Office Action Summary	Application No. 10/561,422	Applicant(s) SORGE, KAI	
	Examiner ALEXANDER B. COMLEY	Art Unit 3746

DETAILED ACTION

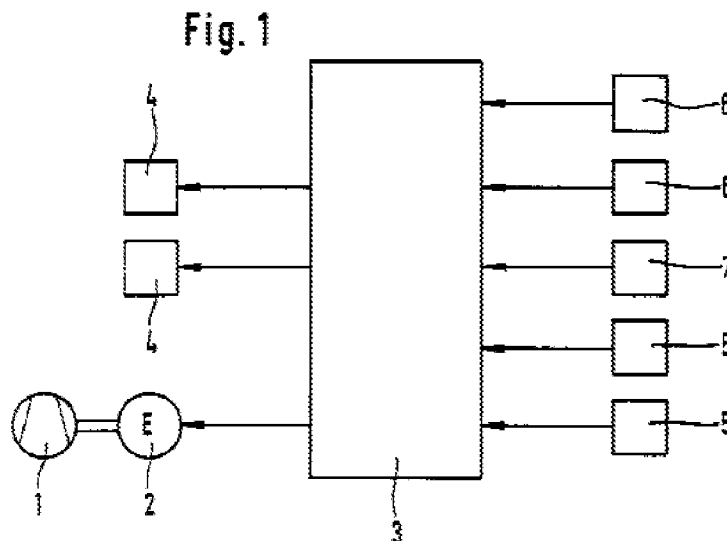
2. **Claims 13-14, 17-18, 20, & 24** are rejected under 35 U.S.C. 102(b) as being anticipated by United States Patent to Kutscher et al. (6,212,451) to a Pneumatic Suspension Leveling System for Vehicles.

Regarding Independent **Claim 13**, and in reference to Figure 1 shown immediately above, Kutscher et al. (6,212,451) discloses:

In reference to Figure 1 shown above, Kutscher discloses a compressor control system that cycles a compressor unit on or off, depending on estimated threshold heating/cooling values that are indirectly calculated using a thermal modeling analysis. Thermodynamic properties between the compressor and the surrounding air are also taken into account when calculating these values. In particular, Kutscher discloses, "The invention is based on the concept of selectively varying the compressor on-time (relative and absolute), whereby the current on-time duration in each case is matched to prevailing compressor operating conditions. The functional parameter for determine a desirable compressor on-time duration is varied are the heat transfer conditions which prevail between the compressor and the air enveloping the latter." (Column 2, Lines 13-21) Kutscher further discloses "These temperatures are preferably detected by an appropriate sensory mechanism, whereby signal values correlating thereto are generated, which the control device processes to determine air temperature in the compressor environment. Accordingly, air temperature in the compressor environment is not measured directly in this compressor environment but, rather, is indirectly determined with the aid of a corresponding, modeling analysis based on the outside vehicle temperature and vehicle engine air-intake temperature. In this manner, recourse

3. Regarding dependent **Claims 14 & 17-18**, Kutscher discloses a compressor operating process that determines a set of physical compressor-influencing variables (i.e., ambient temperature of surroundings, air flow speed), uses these values to estimate an overall compressor temperature, and then determines, based on these values and current operating requirements, exactly how the compressor should function at a given instant in time. Applicant’s use of subtracting a cooling value or adding a heating value to acquire the estimated relative temperatures is a step that would naturally occur in such a system process. In particular, Kutscher discloses “The heat transfer conditions prevailing between the compressor and the air enveloping the latter can depend to a large extent on the air temperature and air flow speed prevailing in the compressor environment. With a preferred special embodiment of the pneumatic suspension leveling system in accordance with the invention, therefore, the control device is able to vary the on-time duration of the compressor as a function of the air temperature and air flow speed prevailing in the compressor environment.” (Column 2, Lines 22-30) In regards to dependent **Claim 20**, Kutscher discloses using initial relative temperature values that correspond to ambient air temperature surrounding the compressor. Kutscher also specifically notes that such starting values should be based on the particular compressor model to be used (See Column 3, Lines, 59-61; Column 4, Lines 10-13; Column 4, Lines 27-29) In particular, Kutscher discloses “The following

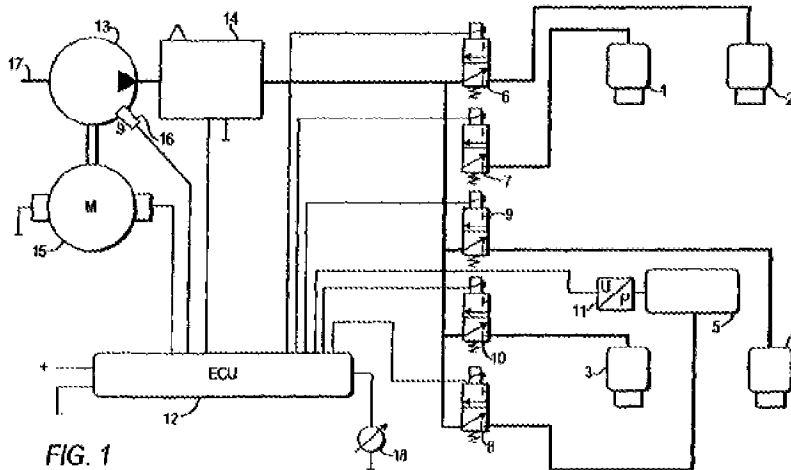
6. **Claims 15-16, 19, & 21** are rejected under 35 U.S.C. 103(a) as being unpatentable over United States Patent to Kutscher et al. (6,212,451) to a Pneumatic Suspension Leveling System for Vehicles in view of United States Patent to Meier et al. (6,799,950) to a Method and Apparatus for Controlling a Compressor.

In regards to dependent **Claim 15**, and in reference to Figure 1 shown immediately above, the Meier portion of the combination specifically discloses using the backpressure in the compressor system in order to accurately estimate compressor temperature. In particular, Meier discloses "A method and apparatus for controlling a compressor suitable for delivery of pressurized fluid to a pressurized fluid system, wherein the delivery of the pressurized fluid to the pressurized fluid system can be cycled on and off as a function of a temperature signal received from a temperature sensor. The delivery of pressurized fluid is turned off when the temperature signal

exceeds a temperature limit value that is based on the backpressure caused by the pressurized fluid system.” (Abstract) Regarding dependent **Claim 16**, the Kutscher portion of the combination discloses a compressor operating/heating function that first calculates a set of physical compressor-influencing variables (i.e., ambient temperature of surroundings, air flow speed), uses these values to estimate an overall compressor temperature, and then determines (based on operating requirements) exactly how the compressor should function at a given instant in time. In regards to dependent **Claim 19**, the Kutscher portion of the combination discloses the use of coefficient-based equations to determine the increments of operational time for the compressor under different loadings and sensed surrounding conditions. In particular, Kutscher discloses “On the basis of conceptual models it is now possible for the control device 3 to calculate a signal value S_{LT} from the signal values S_{AT} and S_{FT} made available to it which correlate to the outside vehicle temperature T_{AT} and to the vehicle engine air-intake temperature T_{FT} which correlates to the air temperature in the compressor vicinity. Likewise, with corresponding conceptual models a signal value S_{LG} can be calculated from the signal value F_{FG} correlating to the vehicle speed G_{FG} which correlates to the air flow speed G_{LG} in the compressor environment.” (Column 3, Lines 36-44) Kutscher further explains the specific equations used, and the influencing factors used for each (See Column 3, Line 46 – Column 4, Line 50) From these equations, it is clear that Kutscher’s “influencing variables” serve the same purpose as applicant’s “constant coefficient matrices” in that they characterize the compressor and its surroundings. Furthermore, Kutscher discloses the claimed invention except for the

specific algebraic forms of the operating equations used. However, it would have been an obvious matter of design choice to utilize such equation forms, since applicant has not disclosed that such particular equations solve any stated problem or are for any particular purpose, and it appears that the invention would perform equally well with similar equation forms. Regarding dependent **Claim 21**, Kutscher specifically describes using appropriate starting values for the control system based on corresponding compressors used and their environments. Kutscher also notes that such starting values are to be based on the particular compressor model used (See Column 3, Lines, 59-61; Column 4, Lines 10-13; Column 4, Lines 27-29) Therefore, Kutscher discloses the claimed invention except for the particular initial relative temperature value of "zero". However, it would have been obvious to one having ordinary skill in the art at the time the invention was made to utilize an initial relative temperature of "zero", since it has been held that discovering an optimum value of a result effective variable involves only routine skill in the art. *In re Boesch*, 617 F.2d 272, 205 USPQ 215 (CCPA 1980) Therefore, to one of ordinary skill desiring an efficiently operated compressor unit that avoid damage from overheating, it would have been obvious to utilize the techniques disclosed in Meier in combination with those seen in Kutscher in order to obtain such a result. Consequently, it would have been obvious to one of ordinary skill in the art at the time of the invention to modify the compressor control method of Kutscher with the counterpressure readings seen in Meier in order to obtain predictable results; those results being a more precisely controlled compressor that prevents overheating while avoiding complete reliance on temperature readings for its temperature calculations.
